Addendum I to Environmental Impact Statement

Proposed Composting/Biogas Facility
at Durnish, Foynes, County Limerick

Project title: Greenport Foynes Composting/Biogas Facility EIS

Document Title: Addendum I to Environmental Impact Statement

Foul Sewer Works: Drawing No.061-306-012-P5

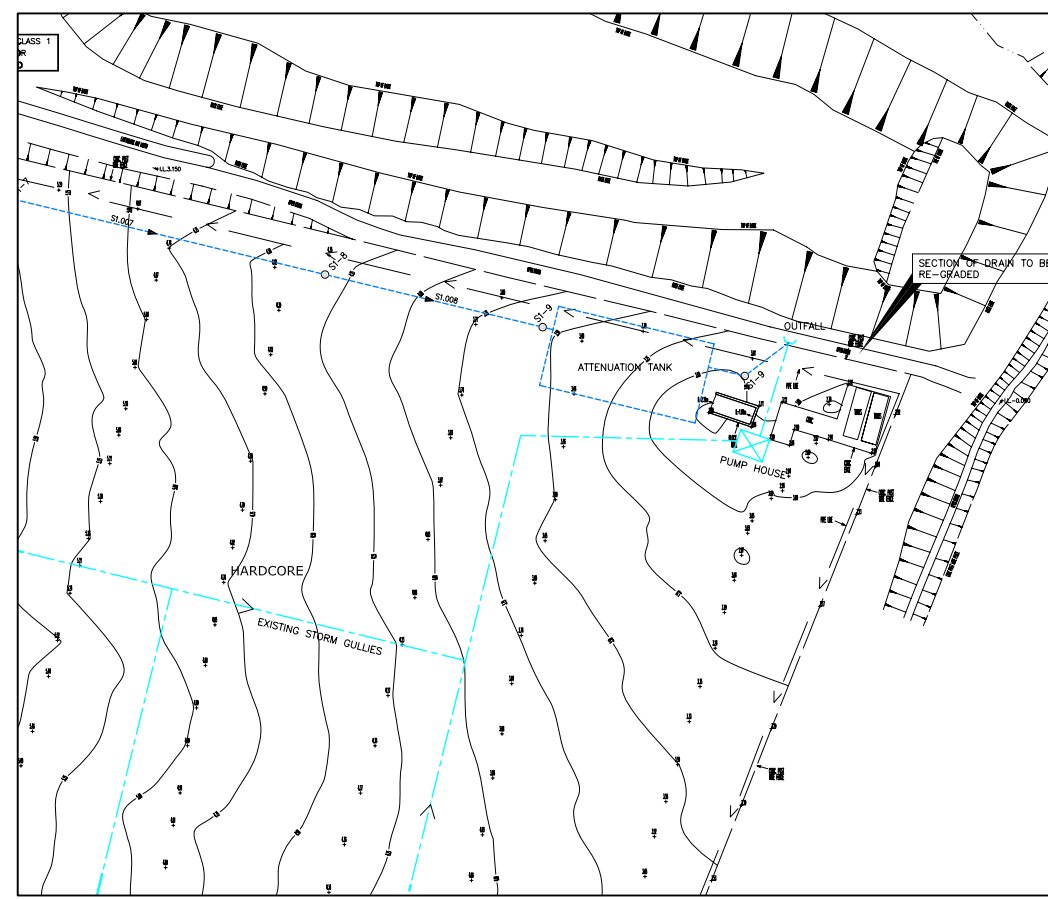
10. Give details of foul sewer works to which the sanitary effluent from the proposed facility is to be discharged. Include Section 4 licence and comment on whether the discharge has agreement from the owner of the system and whether the discharge limits from the works will continue to be observed.

The foul sewer to which the treated effluent from the facility discharges is currently in the ownership of Atlantic Fuel Supply Company (AFSC). The sewer is a 225 mm diameter sewer and currently takes treated effluent from the treatment plant associated with the AFSC development to its discharge point on the estuary. The existing discharge is subject to a discharge licence, which has issued from Limerick County Council.

Michael Punch and Partners, Consulting Engineers for the proposed development, have confirmed that the sewer, as installed, has adequate capacity to cater for the additional flows to contribute from the Greenport facility. This licence limits the discharge to BOD of 20 mg/l, suspended solids of 30 mg/l and pH of 6-9 and prohibits the discharge of mineral oil, diesel range organics and petrol range organics. The licence also limits the discharge to 5 m³/day. The maximum flow anticipated from the 12 PE plant at AFSC is 2 m³/day (based on the licence application).

The proposed treatment plant at Greenport will cater for an initial discharge of 1.2 m³/day and 0.6 kg/day BOD based on a staff level of 20. The 25 PE Plant is capable of taking more than this as it was sized to cater for use of the first floor). The proposed treatment plant will be compliant with the terms of the discharge licence.

- I. Drainage Layout: Please refer to Drawing No.061-306-012-P5, presented in Appendix 5 of this report.
- II. A copy of the Section 4 Licence, presented in Appendix 6 of this report. As required under the conditions of the licence, approval will be sought from the licensing authority in advance of discharge.
- III. The connection to the system has the agreement from Atlantic Fuel Supply Company (AFSC), the owner of the existing system. An agreement was reached with Shannon Foynes Port Company (SFPC) for a wayleave to install and to connect to the foul sewer system. Following meetings with SFPC and AFSC, an agreement was reached with AFSC to connect to the existing foul sewer system.

Emission Points: Drawing No.061-306-045-P0

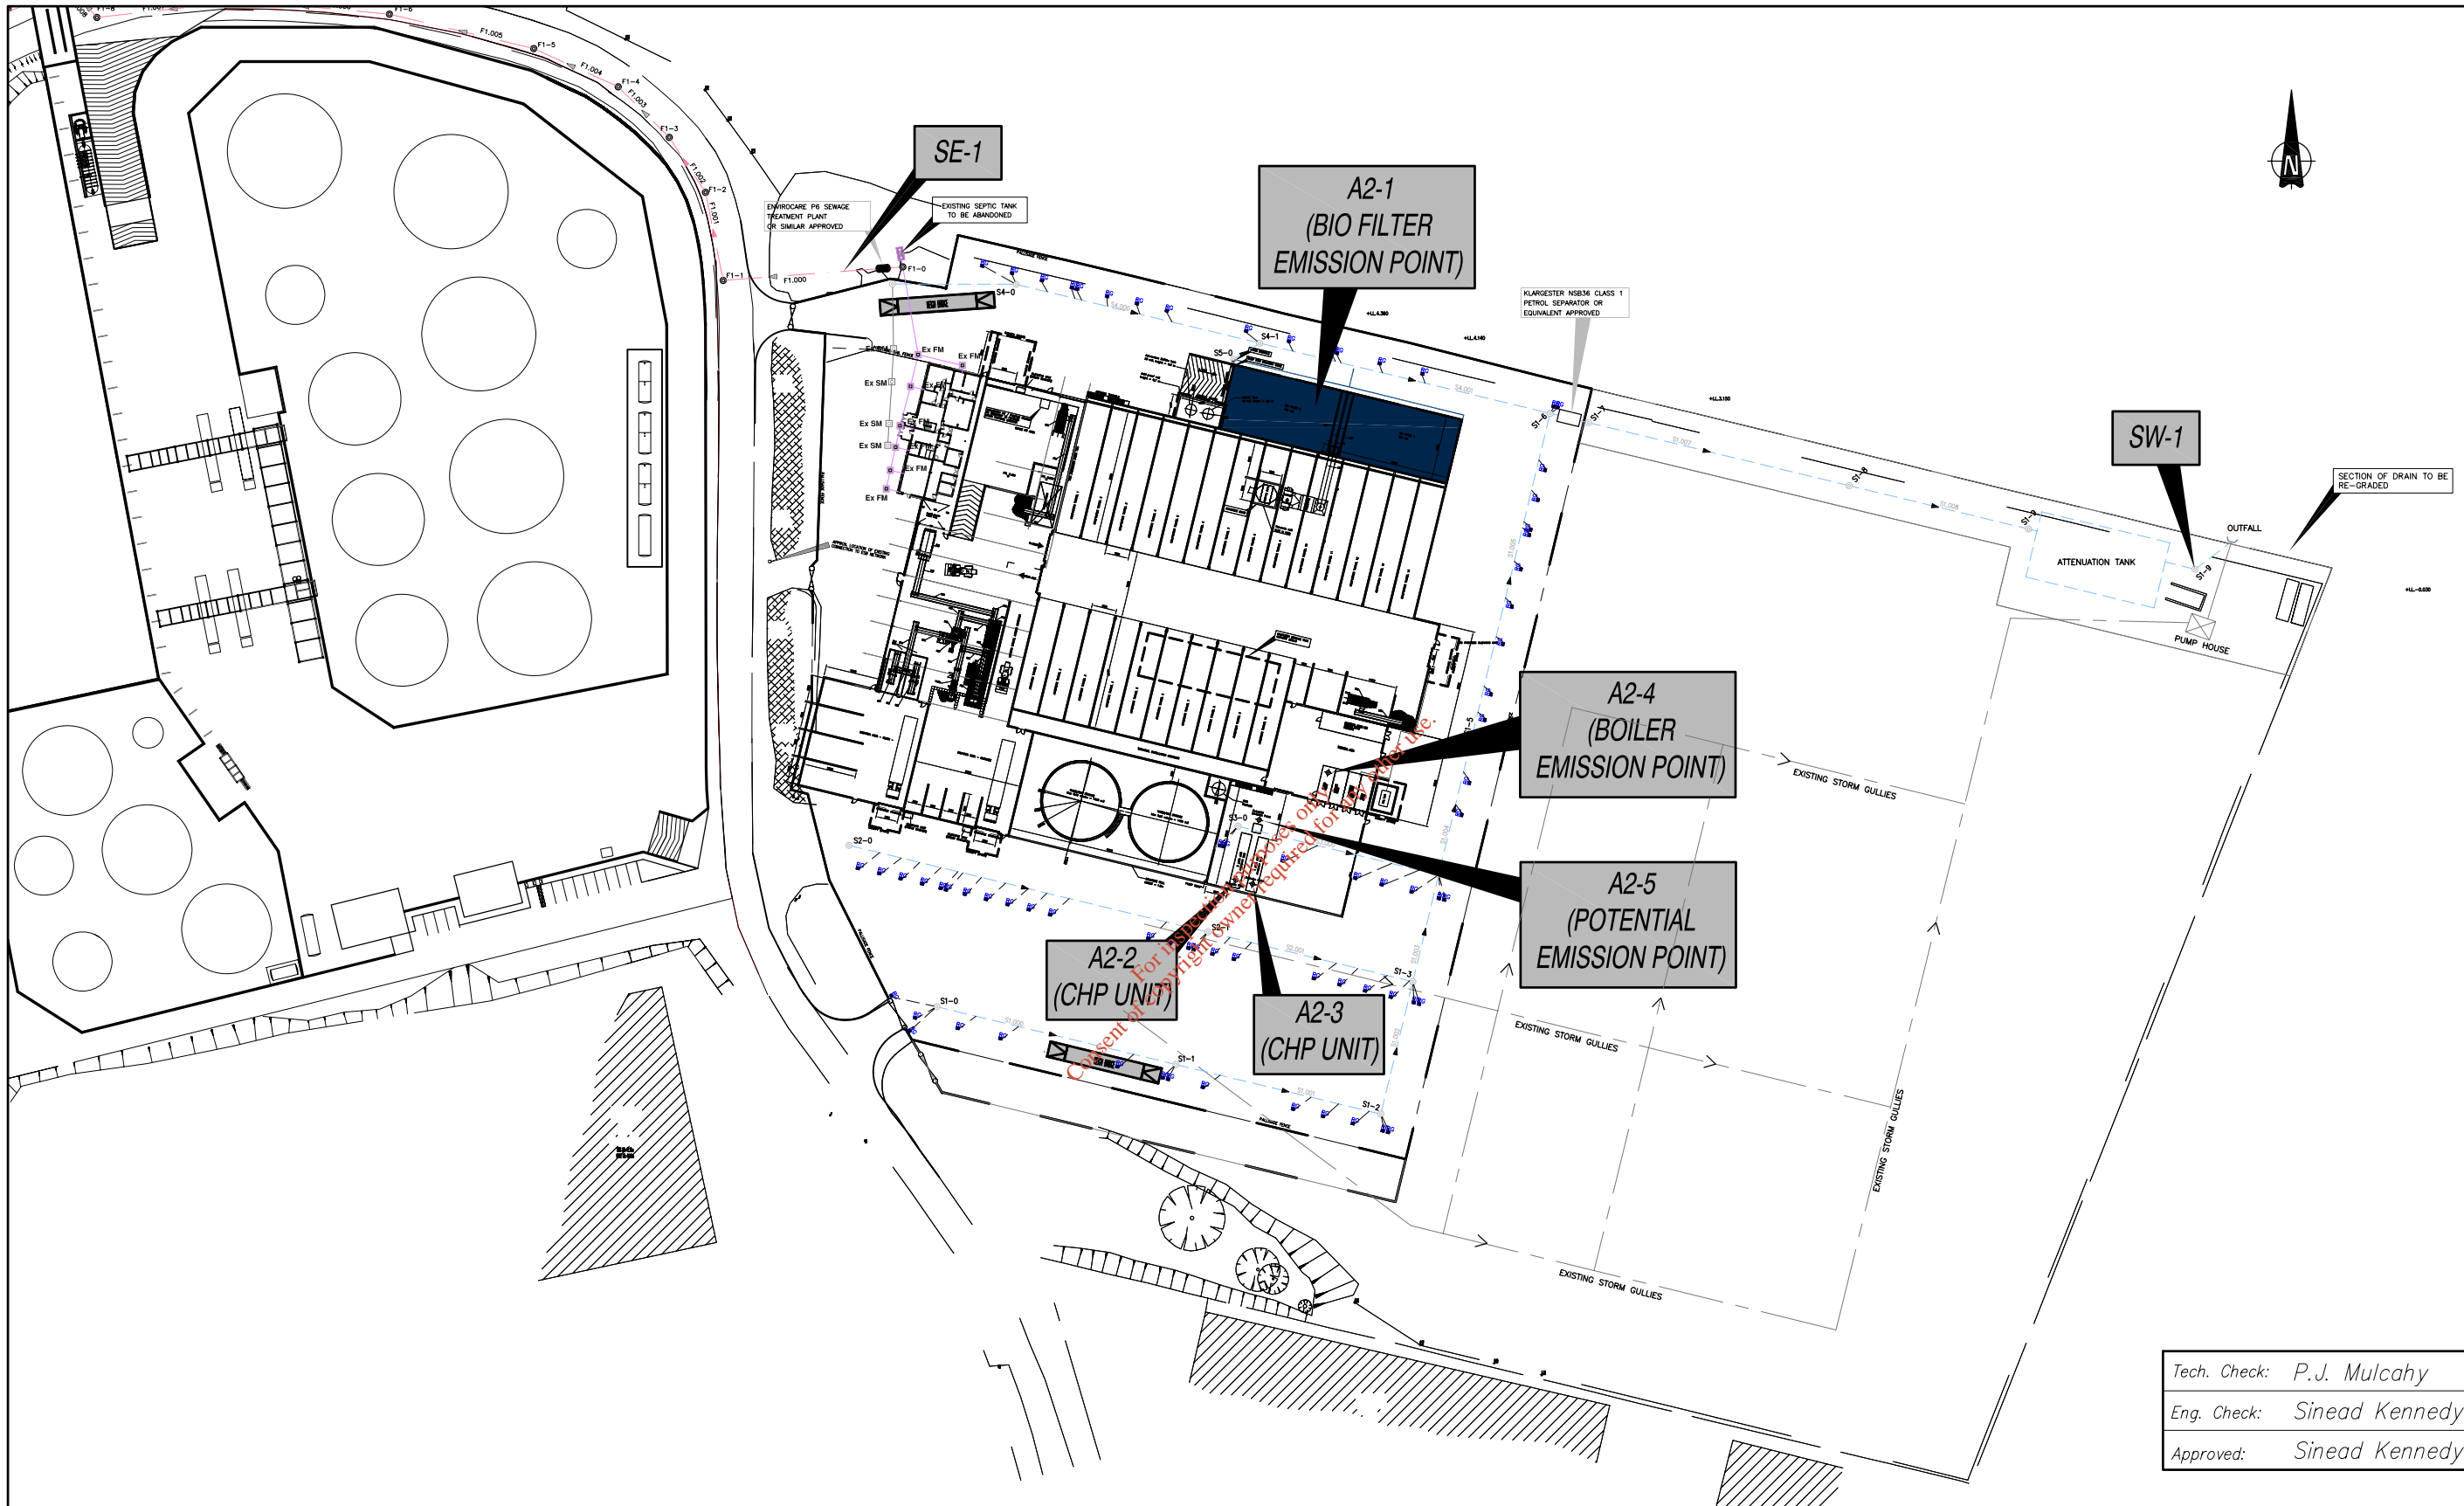
13. Provide a plan identifying all emission points.

Drawing No. 061-306-045-P0 provided in Appendix 7 of this report presents the air, surface water and sewer emission points from the proposed facility.
